BEFORE THE MERIDIAN CITY COUNCIL

**CASE NO. FP-2022-0014

ORDER OF CONDITIONAL
APPROVAL OF FINAL PLAT**

HEARING DATE: 8/9/2022
TO: Mayor & City Council
FROM: Sonya Allen, Associate Planner
208-884-5533
SUBJECT: FP-2022-0014
Outer Banks – FP
LOCATION: Generally located at the southwest corner of W. Franklin Rd. & S. Ten Mile Rd. at 75 S. Ten Mile Rd., in the NE 1/4 of Section 15, T. 3N., R.1E.

B. Final Plat (date: 7/18/2022)

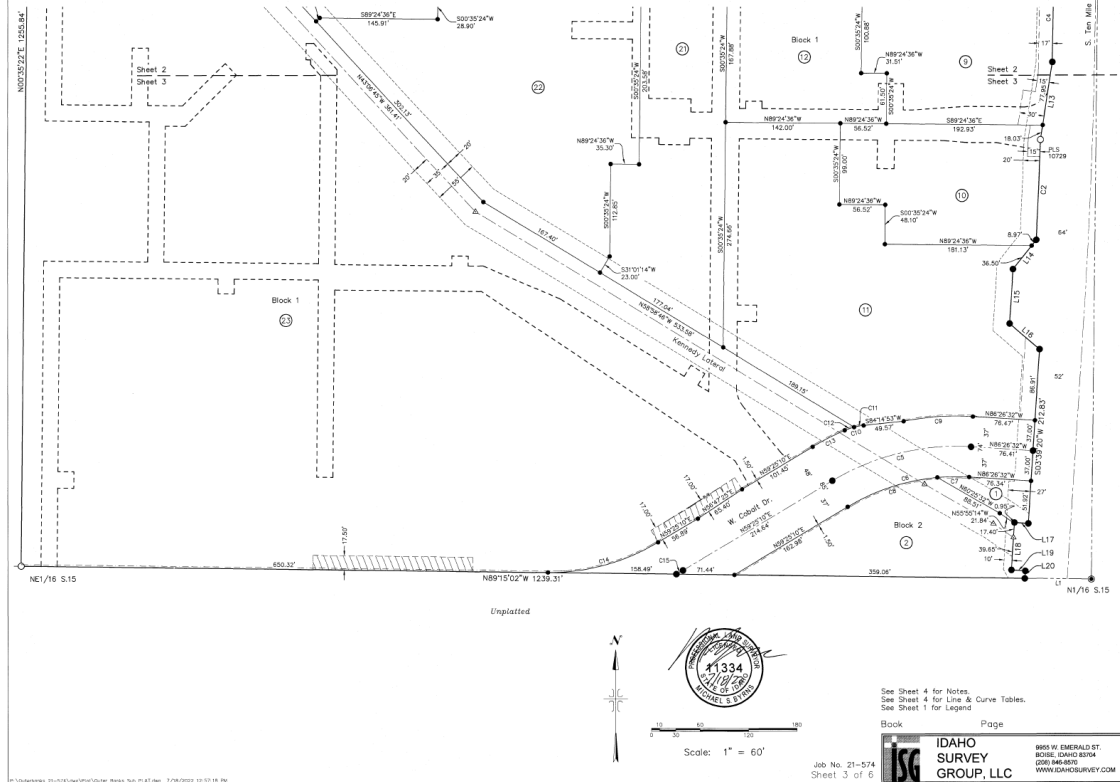
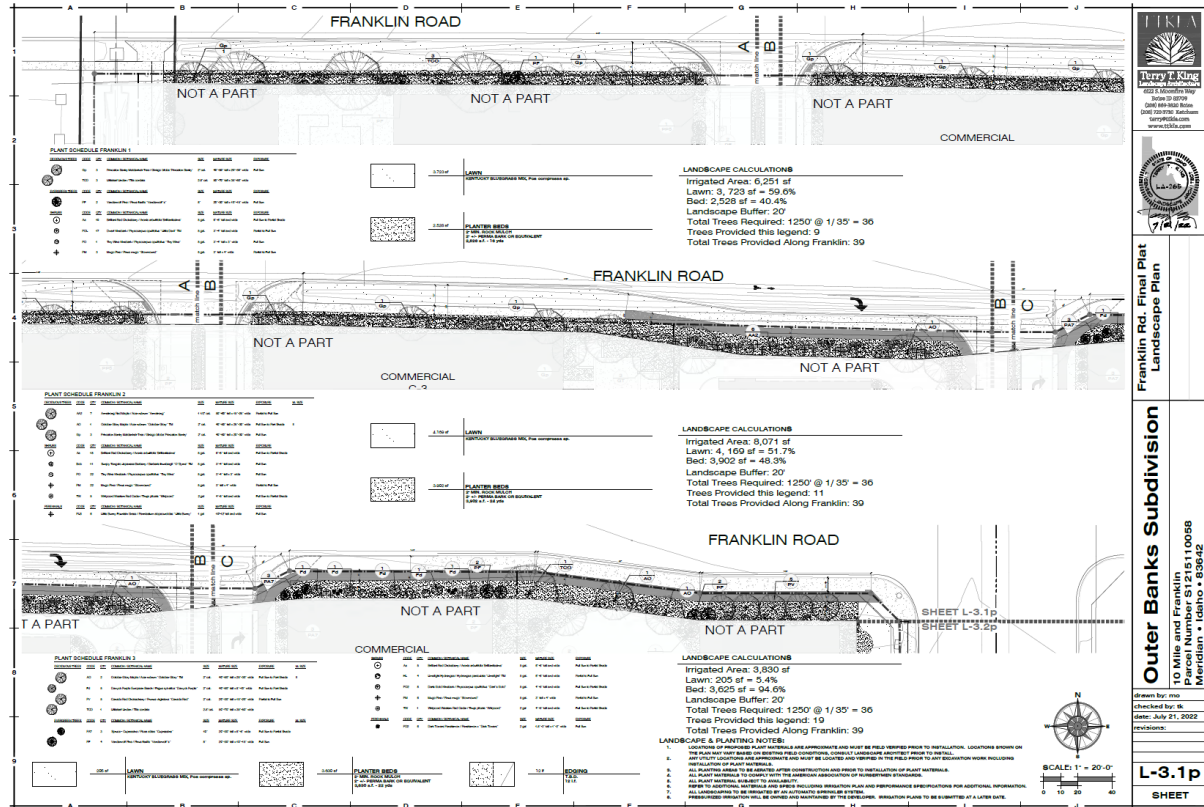
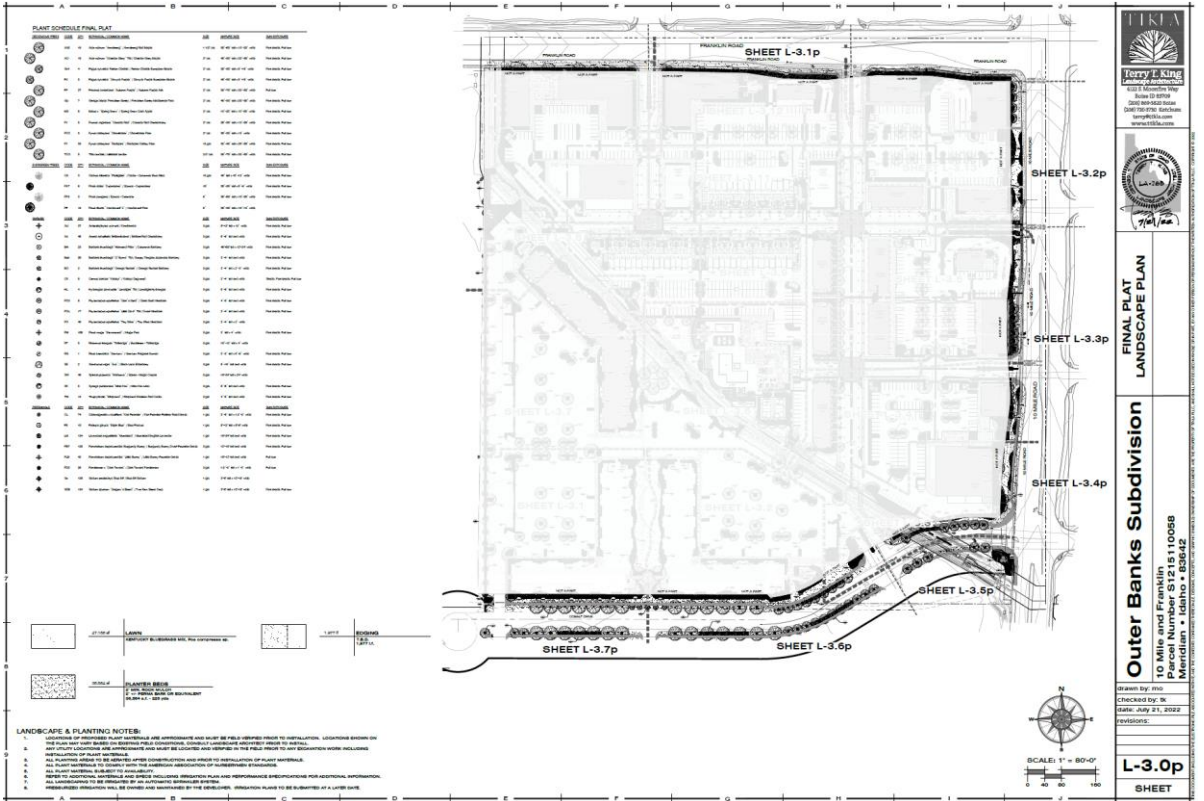
3. Prior to submittal for the City Engineer's signature, have the Certificate of Owners and the accompanying acknowledgement signed and notarized.
4. The final plat shown in Section V.B prepared by Idaho Survey Group, LLC, shall be revised as follows:

- a. Note #5: Include W. Cobalt Dr. in the note.
 - b. Graphically depict all street buffers in a common lot or on a permanent dedicated buffer with a note stating they shall be maintained by the property owner or business owners' association, as set forth in UDC [11-3B-7C.2b](#). *Required street buffers are as follows: minimum 25-feet wide along W. Franklin Rd., an arterial street; minimum 35-feet wide along S. Ten Mile Rd., an entryway corridor; and minimum 20-feet wide along W. Cobalt Dr., a collector street. Street buffers are measured from the back of sidewalk where attached sidewalks are provided and from the back of curb where detached sidewalks are provided per UDC 11-3B-7C.1a.*

- c. The street section for Cobalt Dr. shall include (2) 11-foot wide travel lanes, 6-foot wide bike lanes, 8-foot wide parallel parking, curb, gutter, 8-foot wide planter strips (i.e. tree lawn/parkway) and detached 6-foot wide sidewalks consistent with Street Section D in the [TMISAP](#) (see Pg. 3-21). Parallel parking shall be located to the west of the horizontal curve for Cobalt Dr. and be located beyond the sight distance required for the access proposed on Cobalt Dr. as required by ACHD. **Submit street section that demonstrates compliance with this condition.**

An electronic copy of the revised plat shall be submitted with the final plat for City Engineer signature.

C. Landscape Plan (date: 7/21/2022)

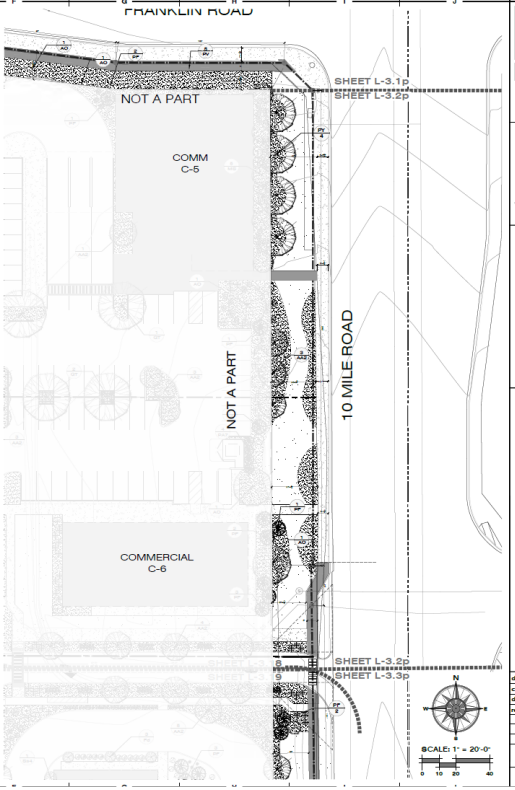
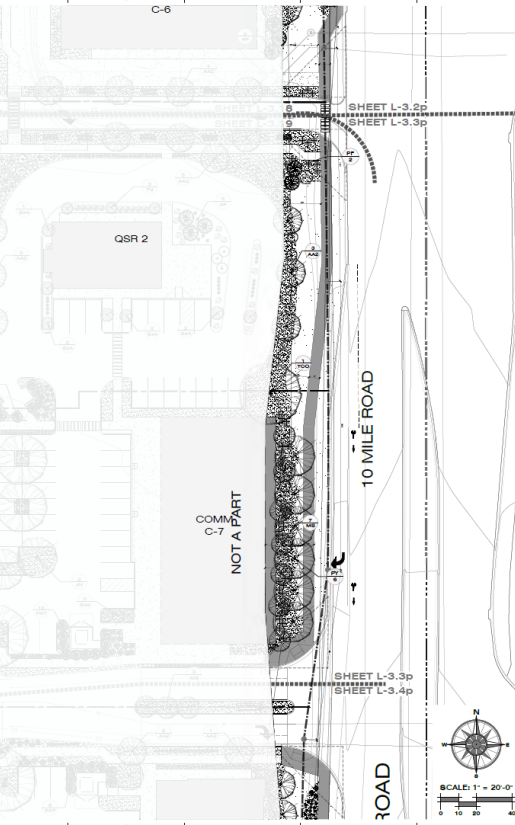
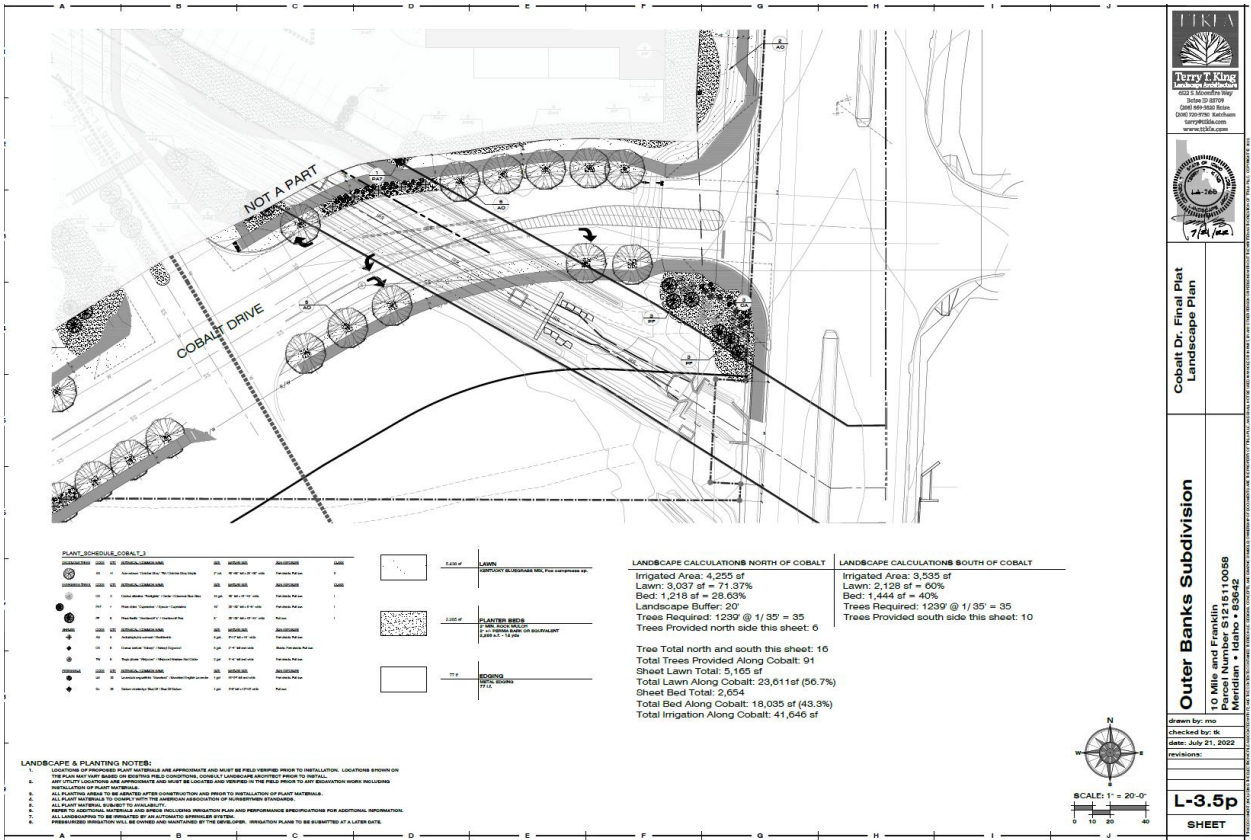
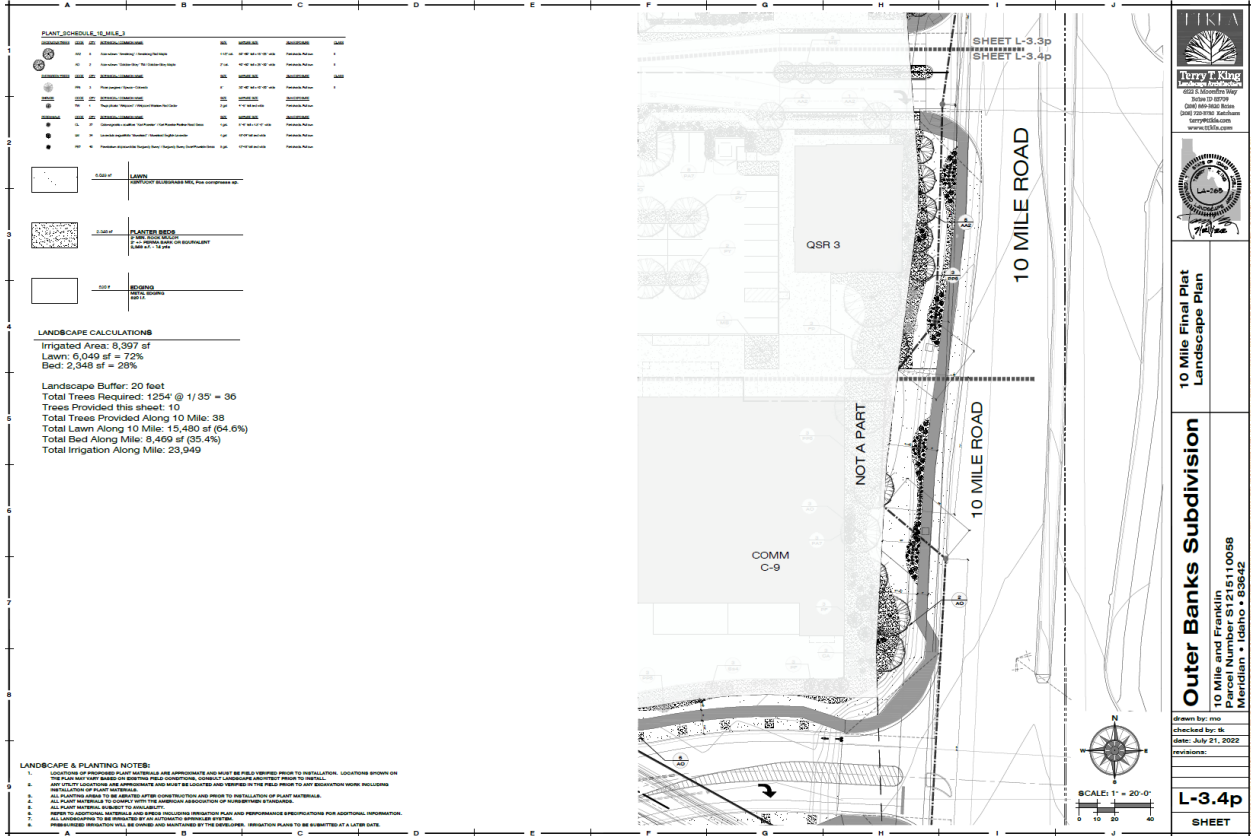
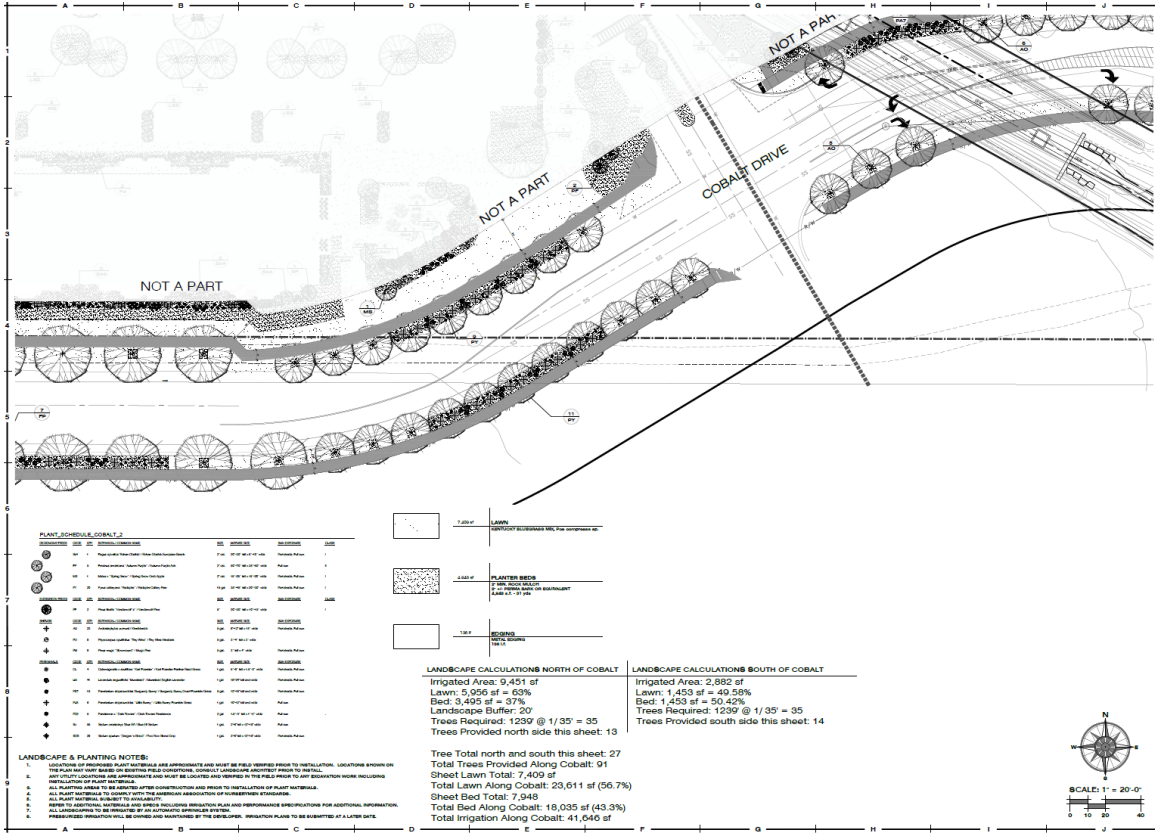
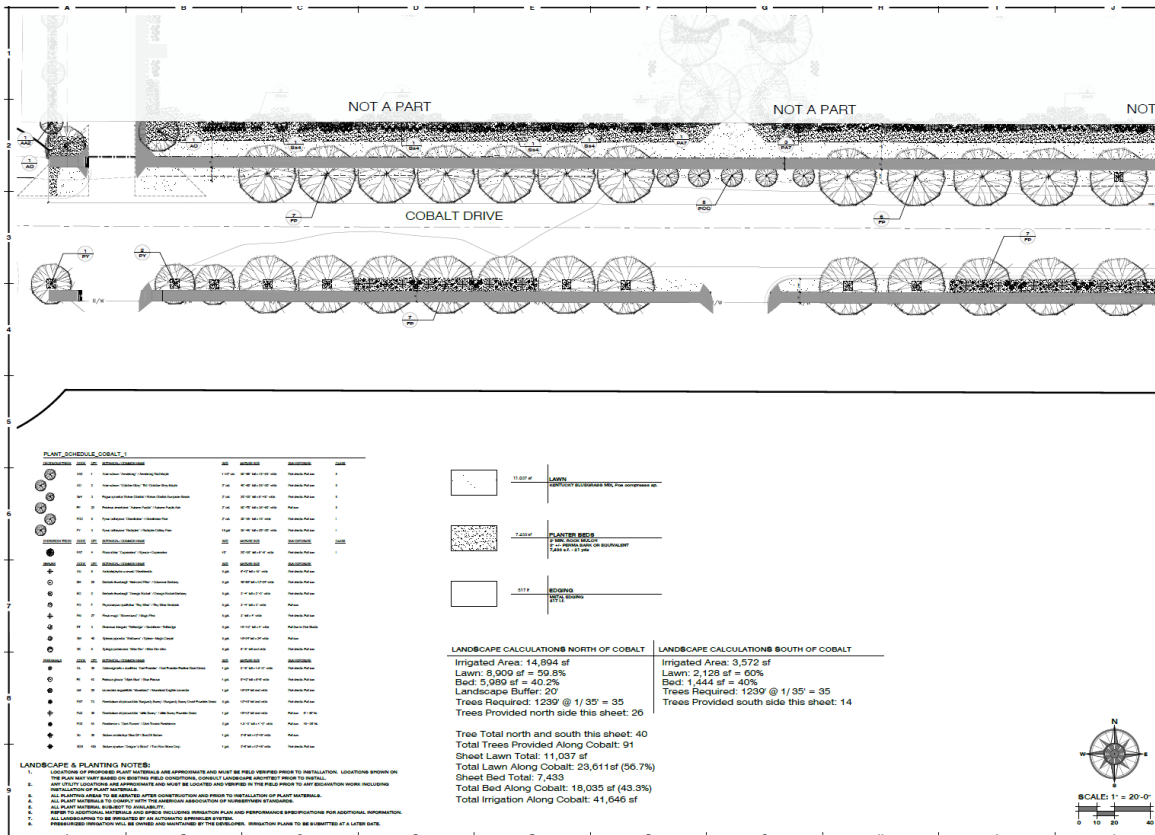
5. The landscape plan shown in Section V.C, dated 4/14/22, shall be revised as follows:
 - a. Include shrubs, along with the trees and lawn or other vegetative groundcover, *within* the required street buffers as set forth in UDC [11-3B-7C](#). The minimum required street buffer widths are as stated above in condition #4b (additional width may be provided); the correct buffer widths should be depicted in the Landscape Calculations tables.

- b. Depict & dimension a minimum 8-foot wide tree lawn along S. Ten Mile Rd. and W. Franklin Rd. and pedestrian-scale street lights consistent with Street Sections A and B in the [TMISAP](#) (see pg. [3-22](#)). Include a detail of the proposed pedestrian lighting. Clearly depict the location of curb and sidewalk on the plans.

- c. Depict & dimension a minimum 8-foot wide tree lawn along W. Cobalt Dr. with street lights in the dry utilities corridor on either side of the street consistent with Street Section D in the [TMISAP](#) (see pg. [3-23](#)). Clearly depict the location of curb and sidewalk on the plans.

- d. Depict & dimension a minimum 6-foot wide detached sidewalk within the street buffer along S. Ten Mile Rd. consistent with Street Section A in the TMISAP (see pg. [3-20](#)). A 10-foot wide pathway is preferred based on ACHD's adopted Livable Streets Performance Measures but not required.

An electronic copy of the revised plan shall be submitted with the final plat for City Engineer signature.

D. Public Art – Conceptual Plan

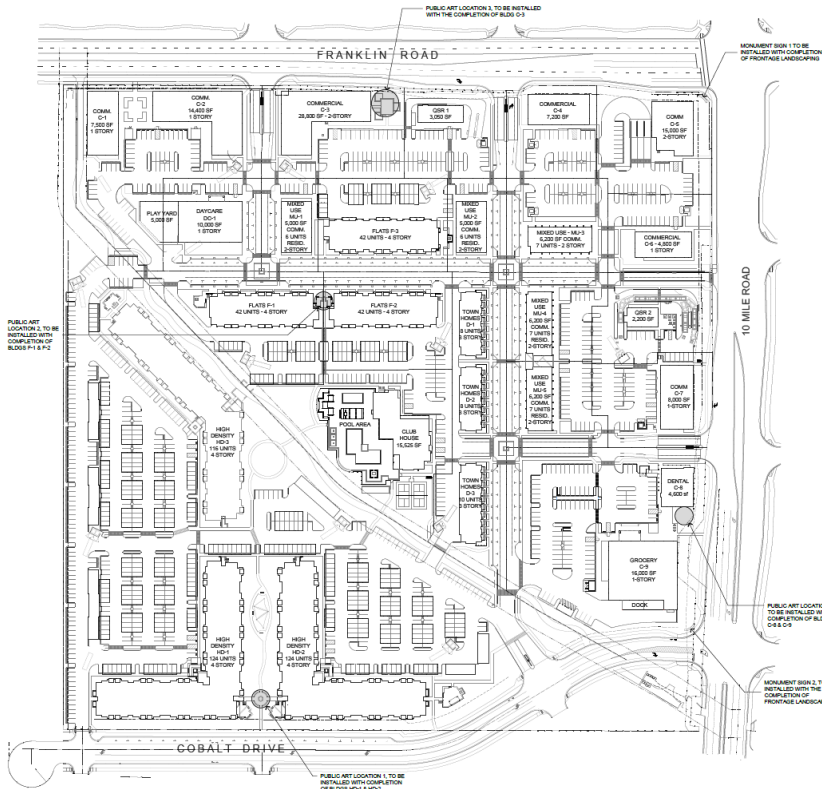
11. Public art shall be provided within the development in accord with the plan in Section V.D, consistent with the Development Agreement and the TMISAP (pg. 3-49).
